Subject: AP1000 Response to Requests for Additional Information (TR 44)

Westinghouse is submitting a revised response to the NRC requests for additional information (RAIs) on AP1000 Standard Combined License Technical Report (TR) 44, APP-GW-GLR-026, "New Fuel Storage Rack Structural/Seismic Analysis." This RAI response is submitted in support of the AP1000 Design Certification Amendment Application (Docket No. 52-006). The information included in the response is generic and is expected to apply to all COL applications referencing the AP1000 Design Certification and the AP1000 Design Certification Amendment Application.

Response to Requests for Additional Information on Technical Report 44

Figure 2-1 New Fuel Storage Rack Layout (72 Storage Location) (Sheet 1 of 2)

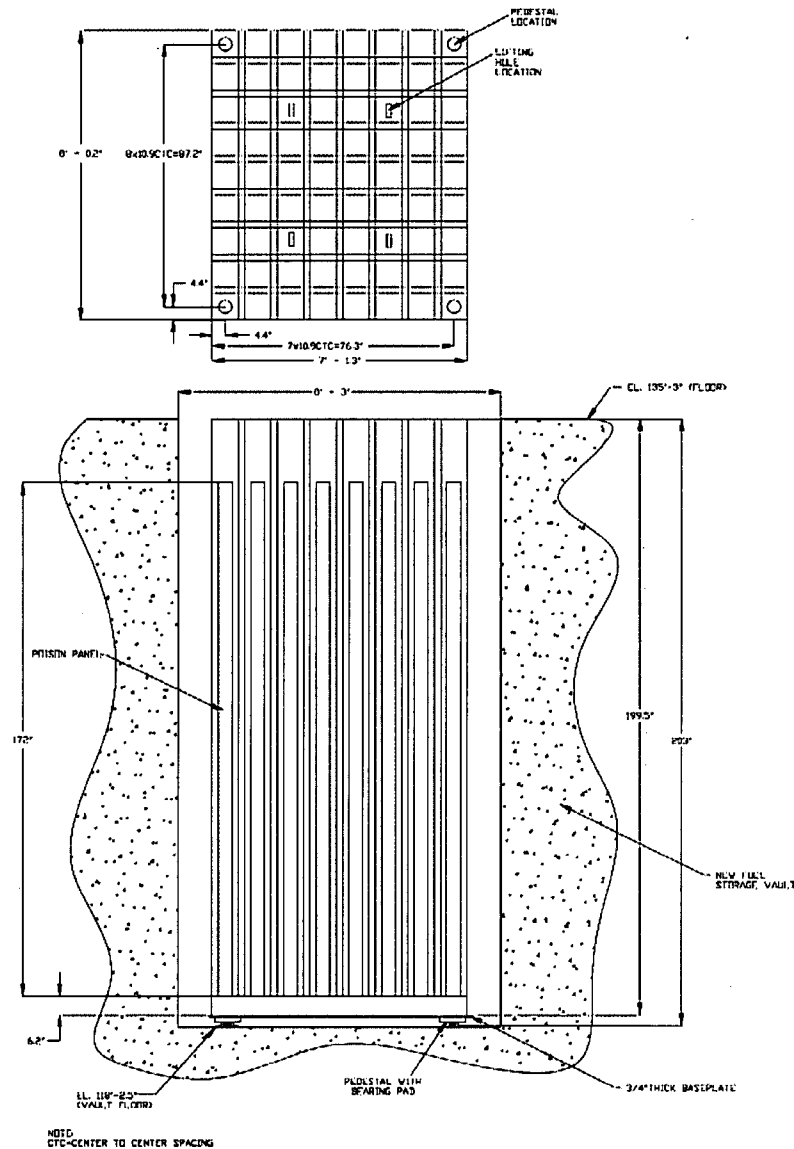
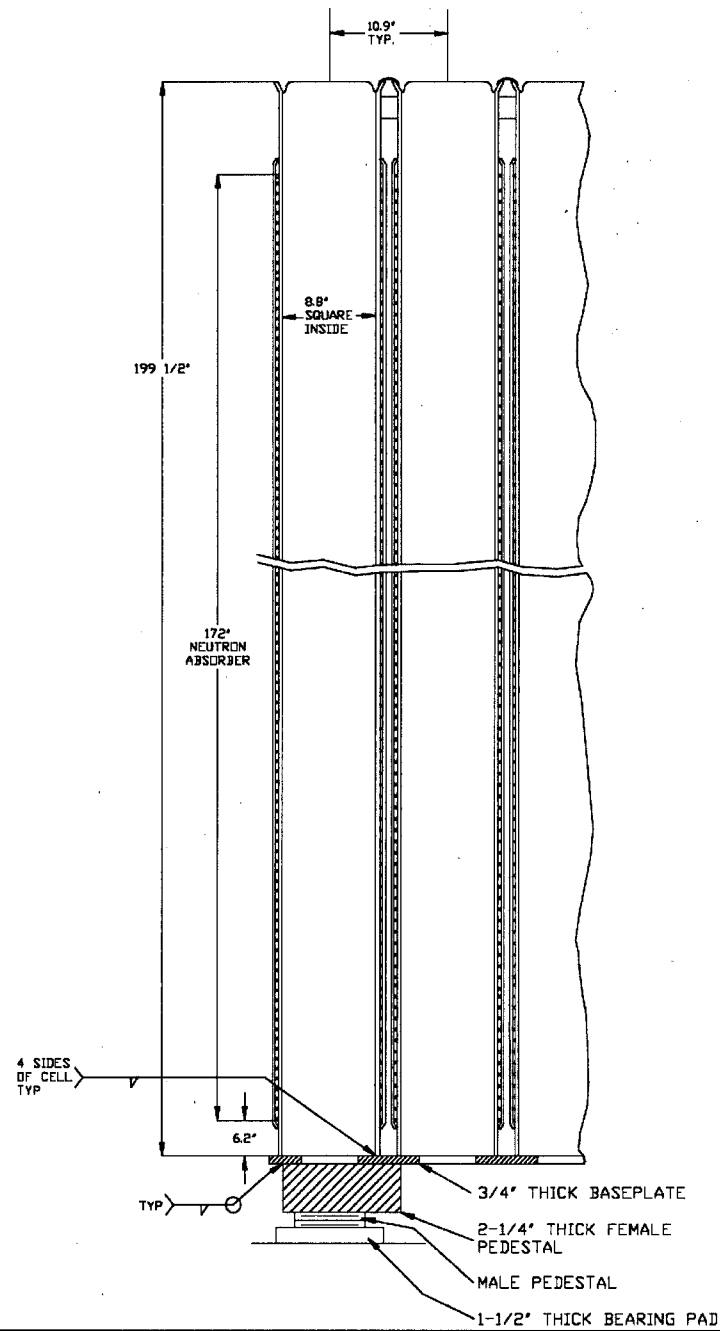
Insufficient descriptive information has been included in the new fuel report to permit an adequate review of the structural/seismic analysis of the new fuel rack. Please provide descriptive information including plans and sections showing the new fuel rack and vault walls. All of the major features of the rack including the cell walls, baseplate, pedestals, bearing pads, neutron absorber sheathing, any impact bars, welds connecting these parts, and any other elements in the load path of the rack should be shown on one or several sketches. These sketches should also indicate related information which includes key: cutouts, dimensions, material thicknesses, and gaps (fuel to cell, rack to walls). In addition to the above, for review of postulated fuel handling drop accident and quantification of the drop parameters, sketches with sufficient details for the fuel handling system should be provided.

The two figures shown in the DCD and TR markup sections provide updates of the layout and cross section of the new fuel storage rack. The figures replaced Figure 2-1 of TR44 and DCD Figure 9.1-1, Sheets 1 and 2; see the DCD and TR markup sections for details.

Technical Report (TR) Revision:
Figure 2-1 was renamed and replaced by the following 2-sheet figure:

Figure TR44-11.1

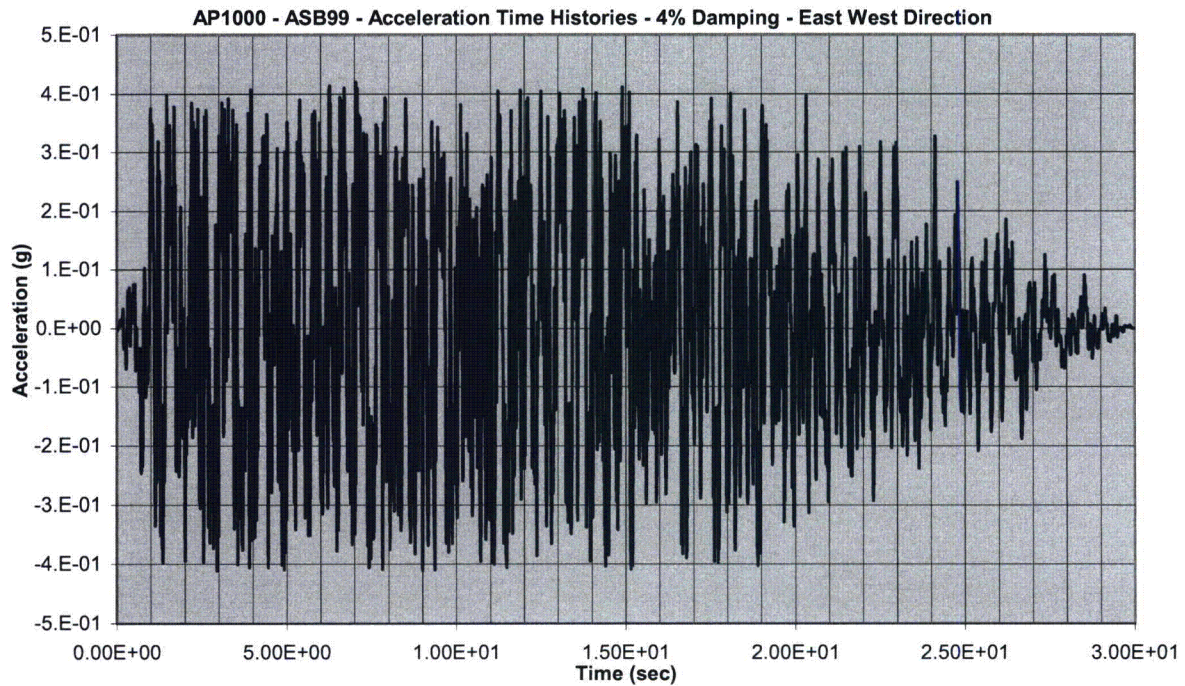
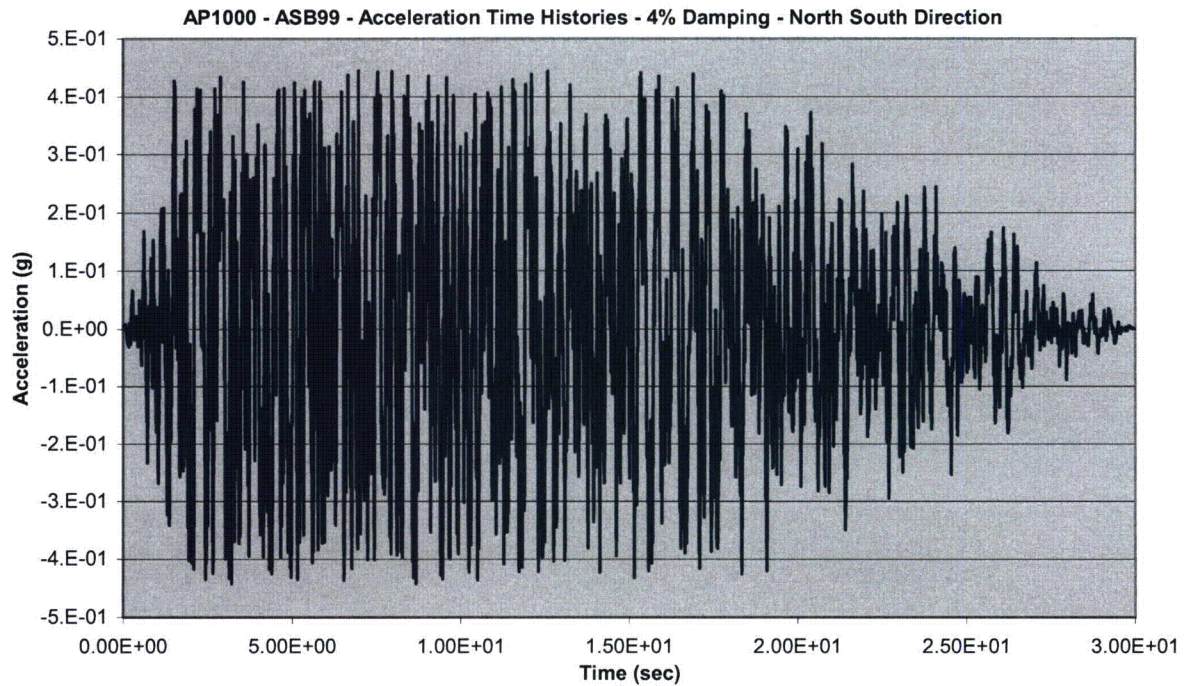
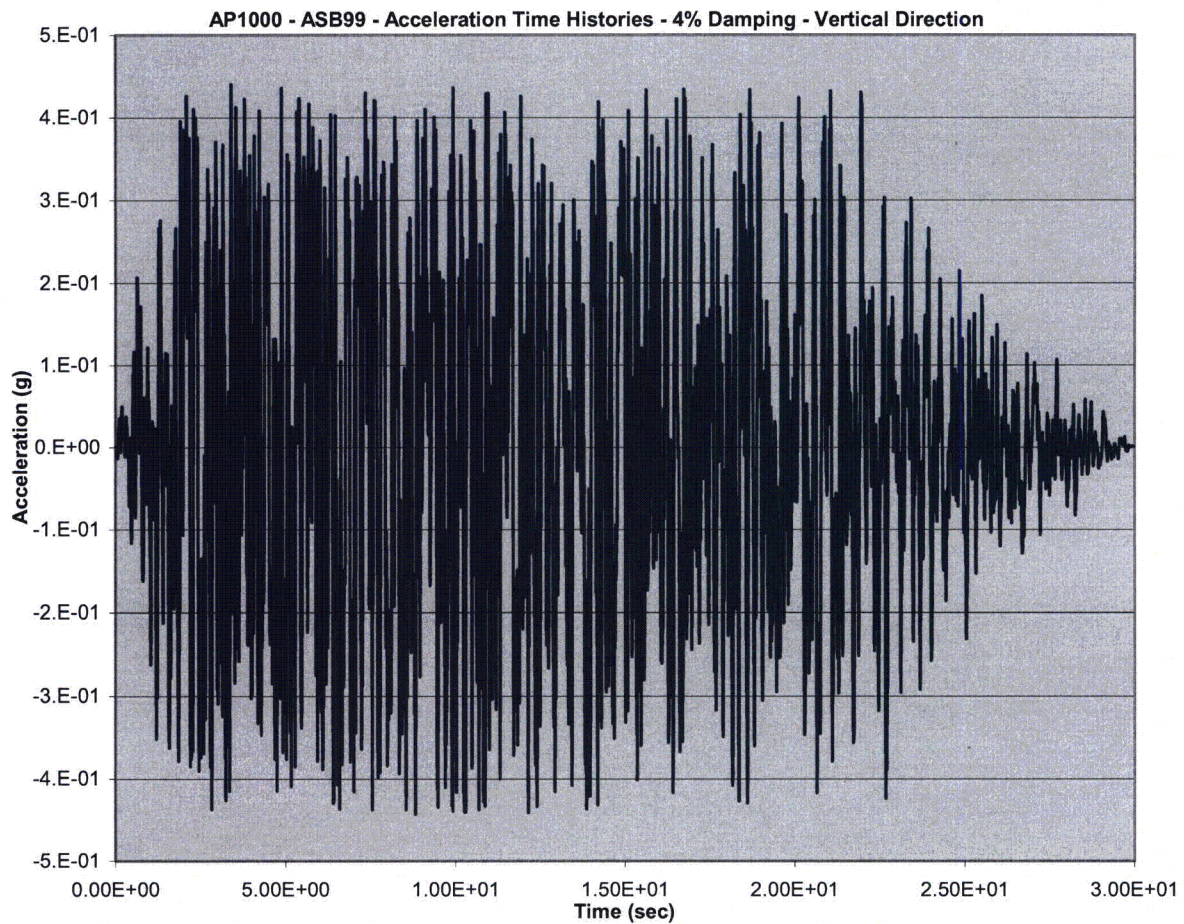
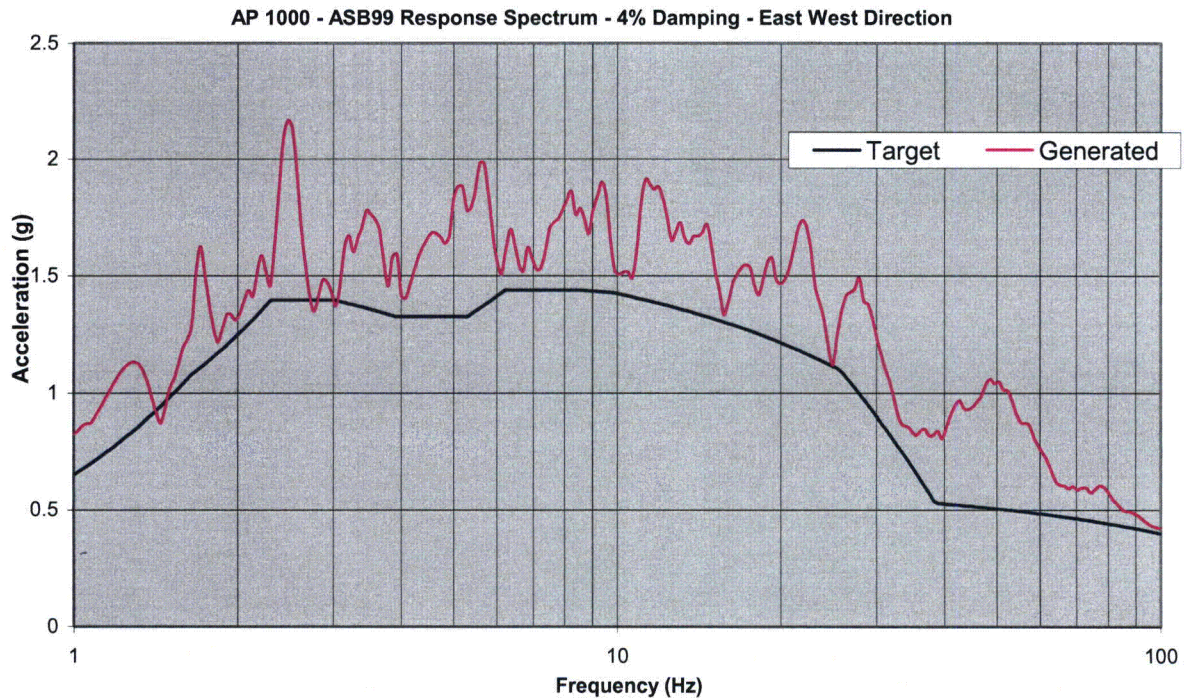
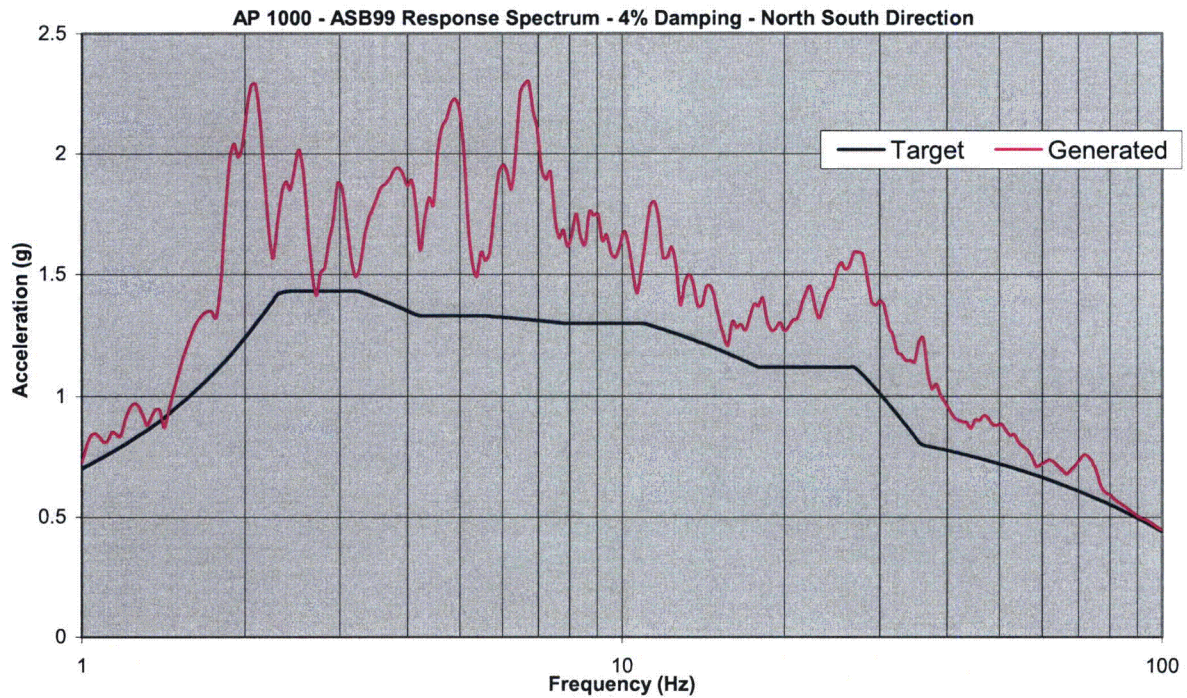
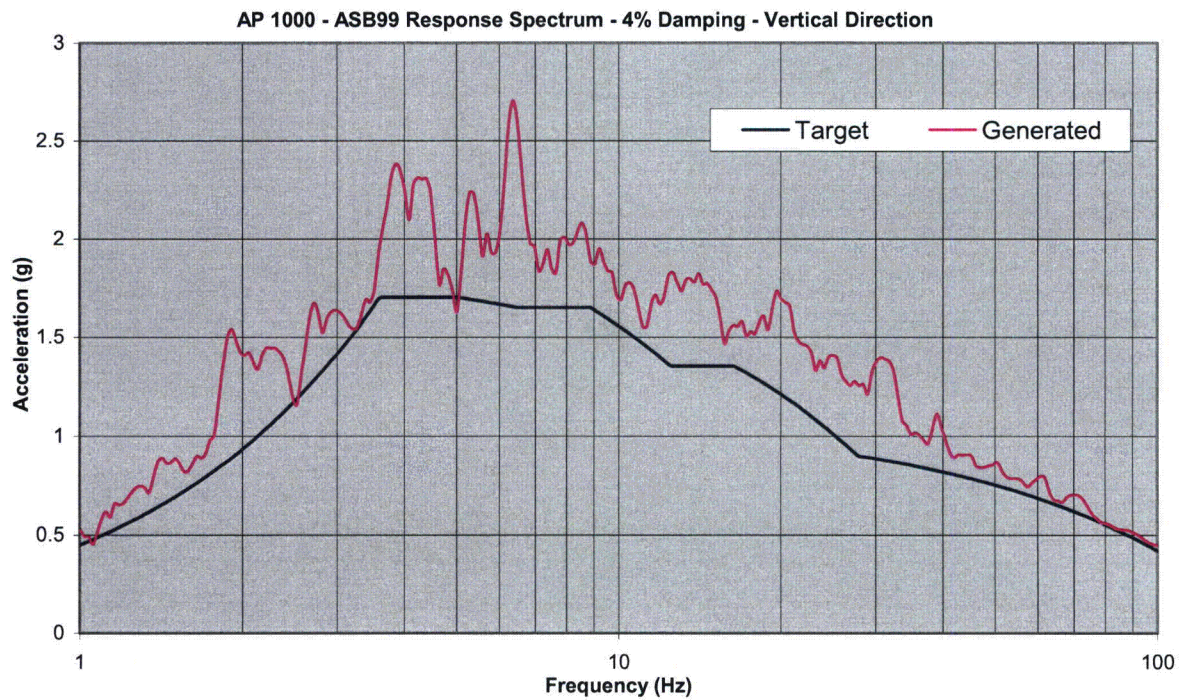
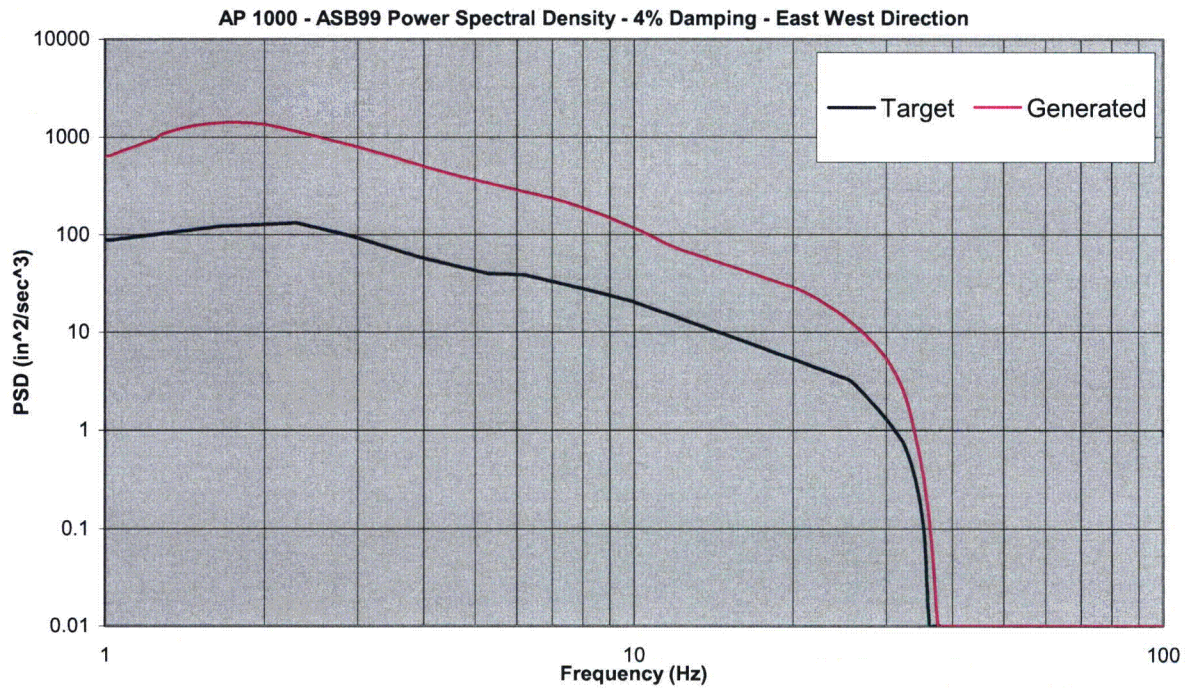
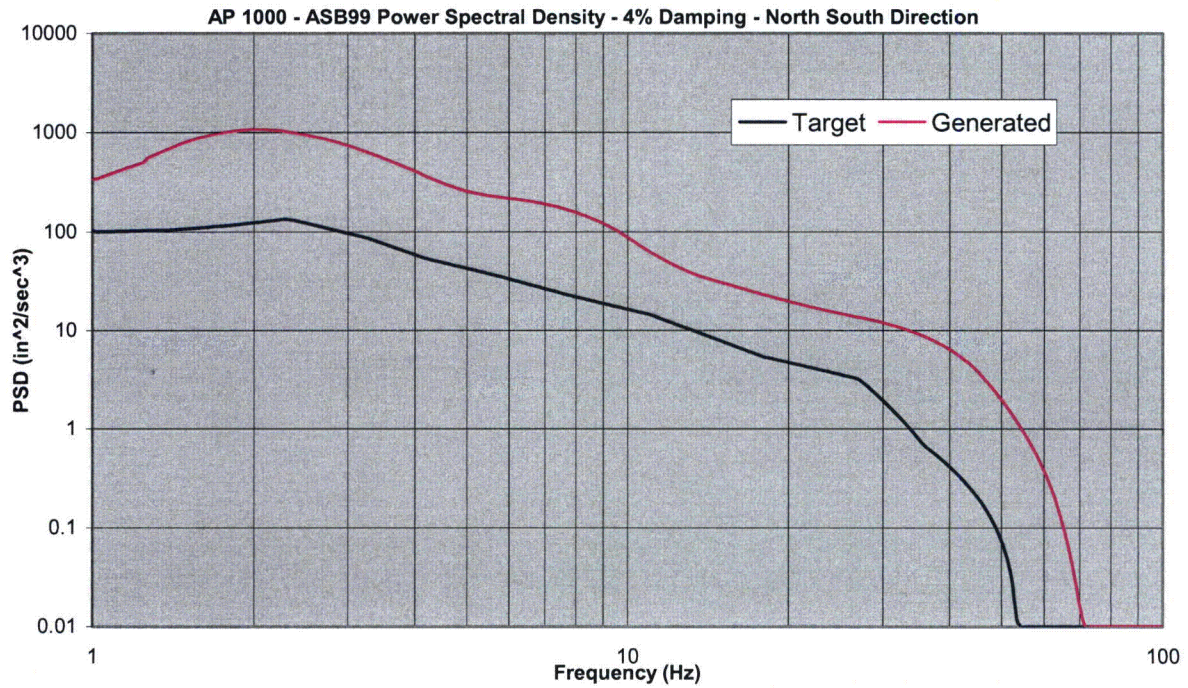
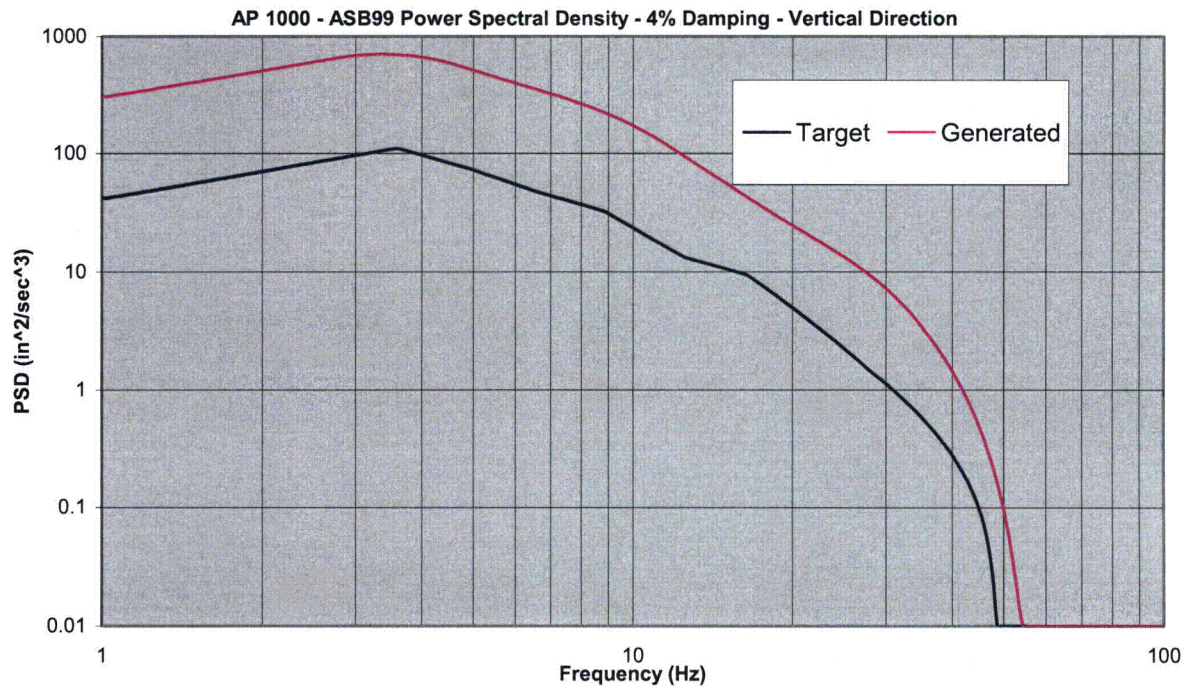
- (d) For the synthetic time histories, provide plots of the three time histories, the cross correlation coefficients, the comparisons of the spectra from the synthetic time histories to the enveloped target response spectra, and the comparisons of the power spectral density plots to the target power spectral density function associated with the target response spectra.

- d) The synthetic time histories, the response spectrum curves, and the power spectral density plots for the Auxiliary and Shielding Building (ASB) at Elevation 99 feet are provided in Figures TR44-11.1 through TR44-11.9. The cross correlation coefficients for the three orthogonal components (East-West, North-South, and Vertical) of the ASB99 synthetic time histories are summarized in the table below.
